Access Compliance Report

Public Rights-of-Way

Intersection ID: 28361	Main Street: CASTLEBAY_DR	Cross Street: TONAWANDA_DR	Location: N
ADA ID: F1858F34B2EB	Ramp Type: Perp	Initial Pass/Fail: Fail	Overall Compliance: No
Severity Score: 21.25			
Codes/Mitigation Info/Possible Solution		Field Measurements/Component Compliance

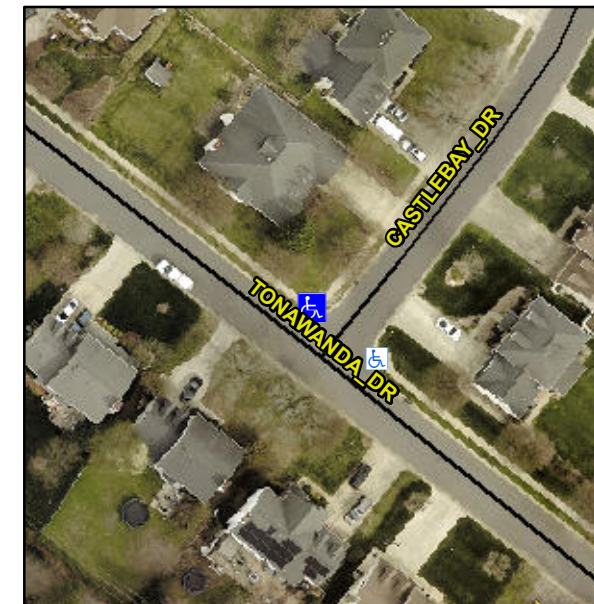
R304.5.1, R304.2.2

Compliance	Description	Data	Compliance	Description	Data
N/A	Ramp Length (in)	44.0	No	Ramp Slope (%)	8.5
No	Ramp Width (in)	45.0	Yes	Ramp XSlope (%)	1.9
N/A	Flare Type LT	N/A	N/A	Flare Type RT	N/A
N/A	Flare Slope LT (%)	N/A	N/A	Flare Slope RT (%)	N/A
N/A	Flare Traversable LT?	N/A	N/A	Flare Traversable RT?	N/A
N/A	Landing Length (in)	N/A	N/A	DWS Provided?	N/A
N/A	Landing Width (in)	N/A	N/A	DWS Contrast?	N/A
N/A	Landing Slope (%)	N/A	N/A	DWS Length (in)	N/A
N/A	Landing X Slope (%)	N/A	N/A	DWS Full Width?	N/A
N/A	Landing Curb? (Y/N)	N/A	N/A	DWS Offset (in)	N/A
N/A	Shared Landing?	N/A			
N/A	Gutter Ponding?	N/A	N/A	Gutter Slope (%)	N/A
N/A	Gutter Lip Ht (in)	0.5	N/A	Gutter X Slope (%)	N/A
N/A	Painted X Walk1?	No	N/A	Painted X Walk2?	N/A
	X Walk 1 Direction	To SW		X Walk 2 Direction	N/A
N/A	X Walk 1 Width (in)	N/A	N/A	X Walk 2 Width (in)	N/A
	X Walk 1 Slope (%)	2.3		X Walk 2 Slope (%)	N/A
	X Walk 1 X Slope (%)	1.4		X Walk 2 X Slope (%)	N/A

Remove & Replace Entire Ramp.
